FEMA APPEAL DOCUMENT

City of San Bruno

Moffatt & Nichol

Date: August 19, 2016
M&N Job No: 9319

Figure 20: FEMA Preliminary FIRM (Left) and Revised Inundation Map under 0.2% Annual Chance Flood (Right)

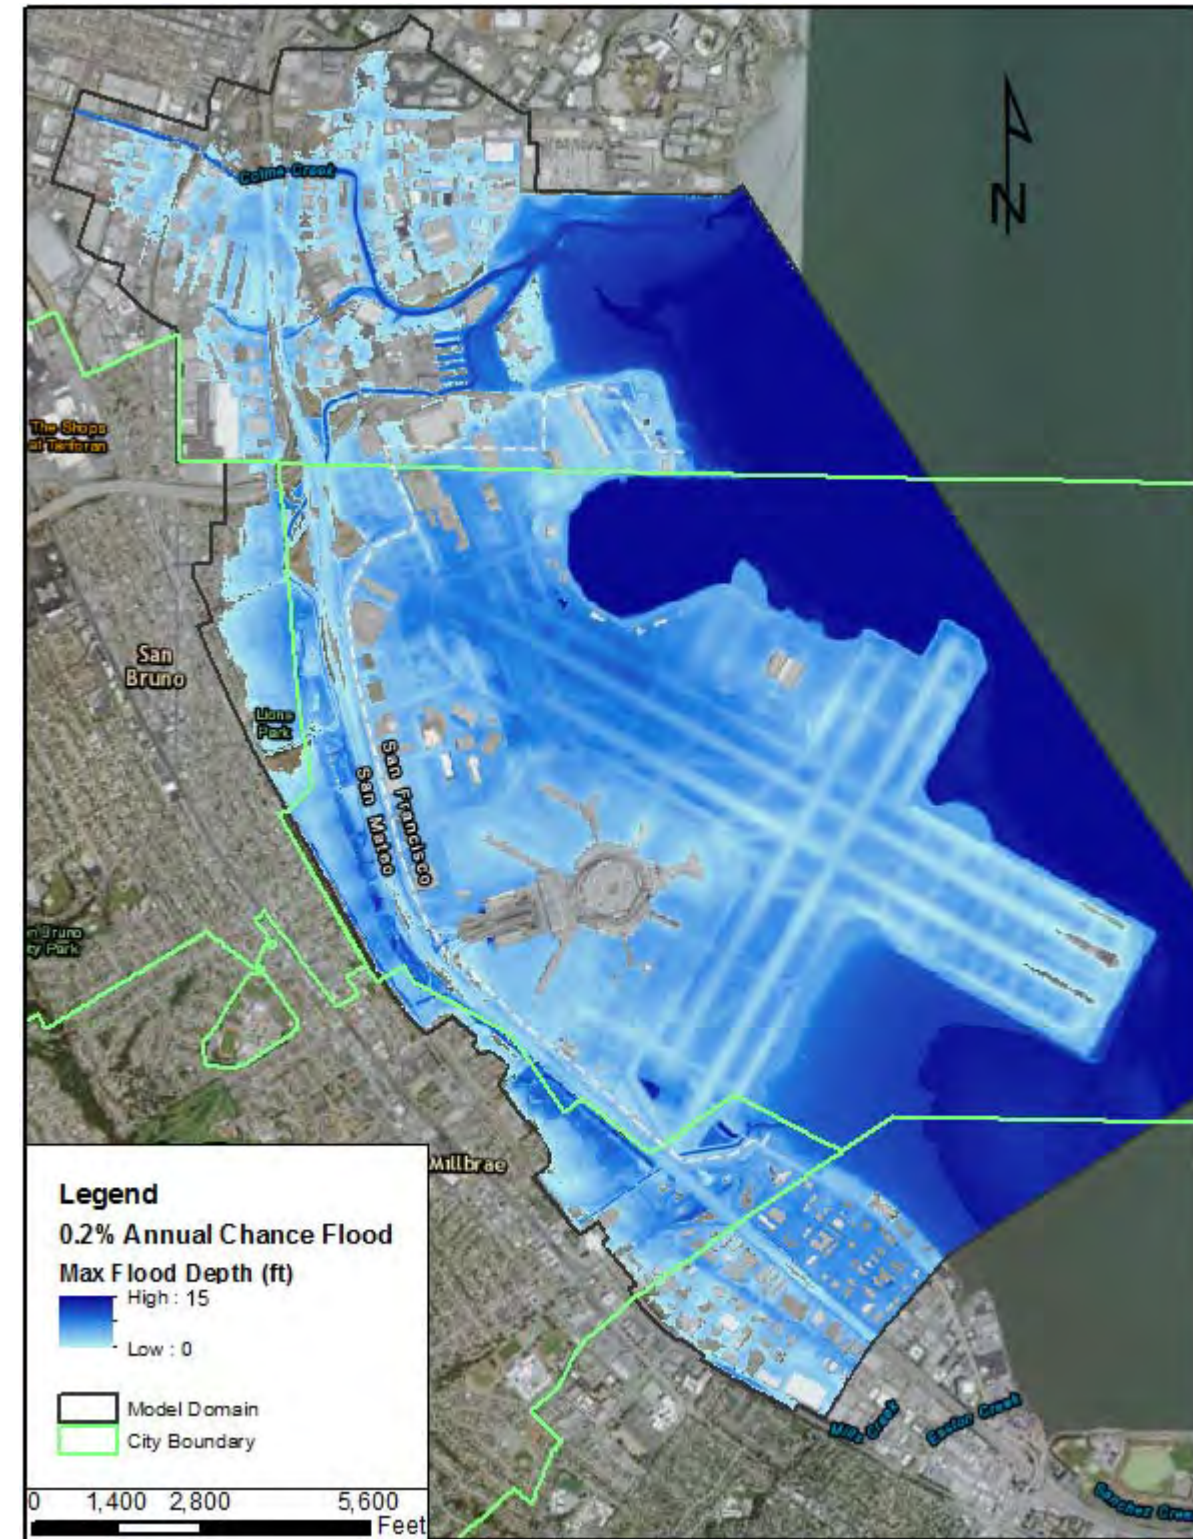
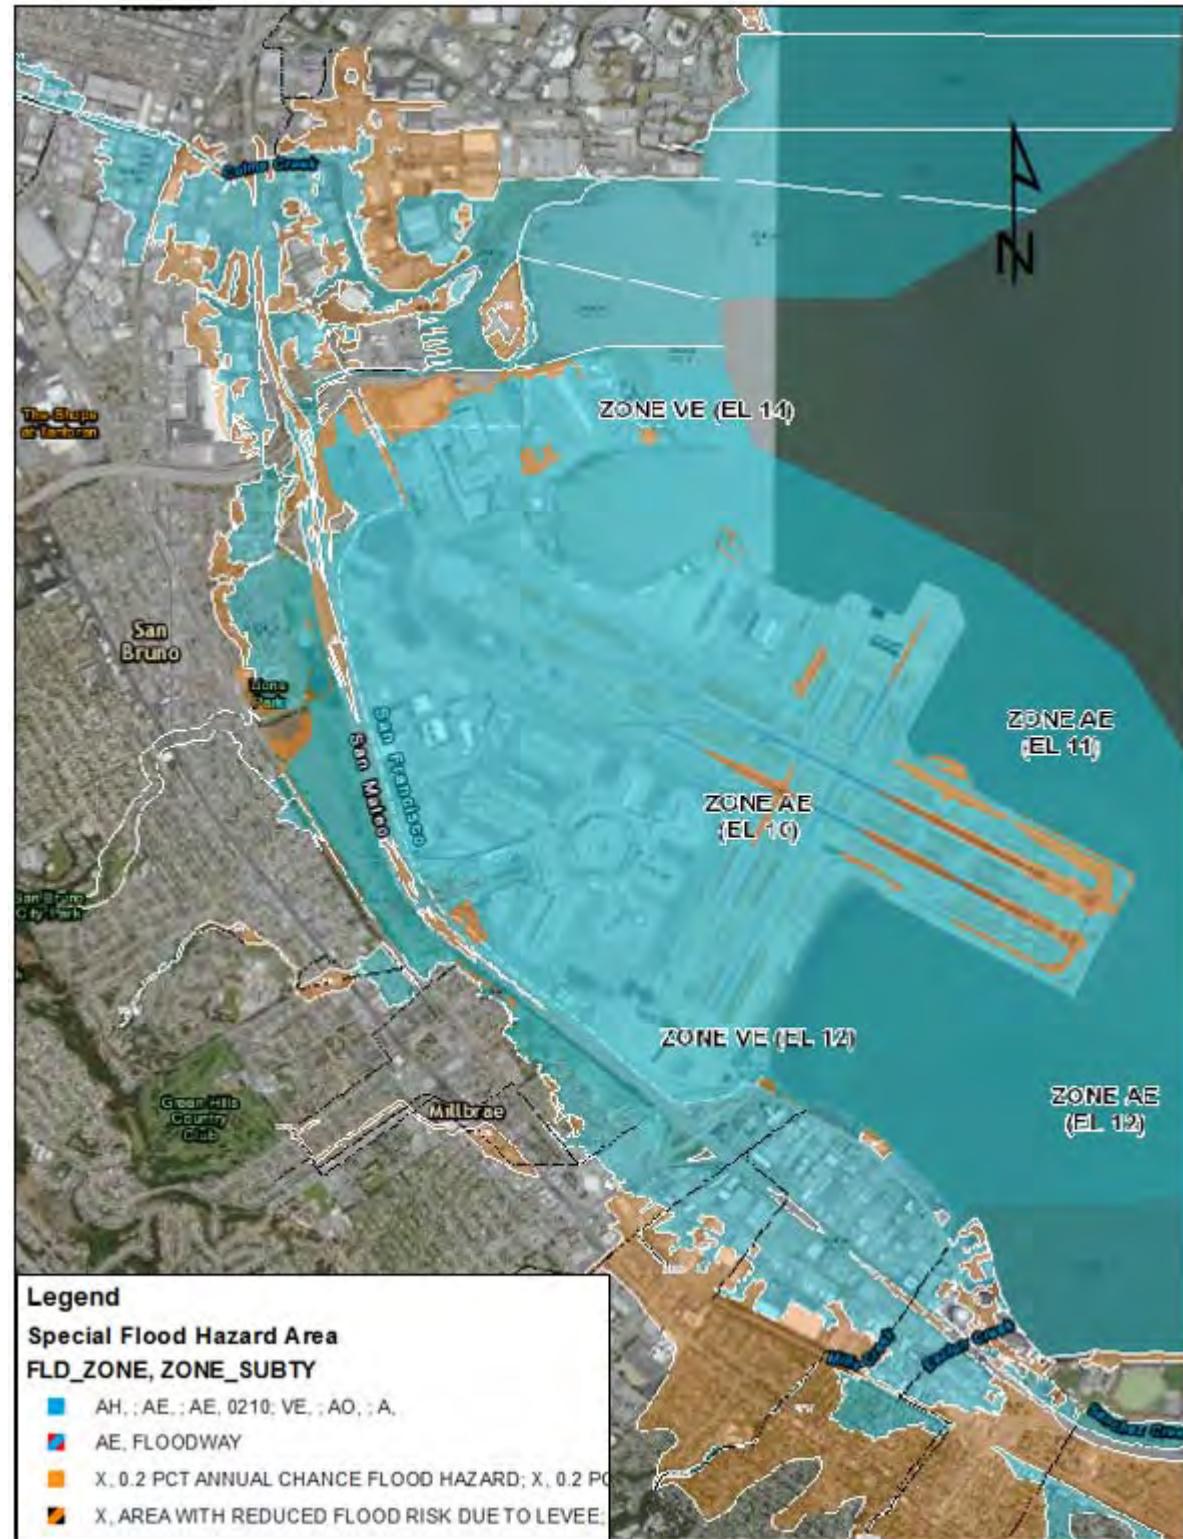
According to FEMA FIRM zone definitions described in Section 1.1, Zone AE are areas of inundation by the 1% annual chance flood with wave heights and runup levels less than 3 feet above the SWEL. Due to the fact that Belle Air neighborhood is located inland and is not subject to wave effects, the modeled inundation area under 1% annual chance flood defines the BFEs and Zone AE boundary for the Belle Air neighborhood. Similarly, Zone X areas are defined as areas that are subject to inundation during storms that are larger than the 1% annual flood but less than the 0.2% annual chance flood. Figure 19 and Figure 20 show the revised inundation areas under 1% and 0.2% annual chance floods with the more accurate alternative analysis.
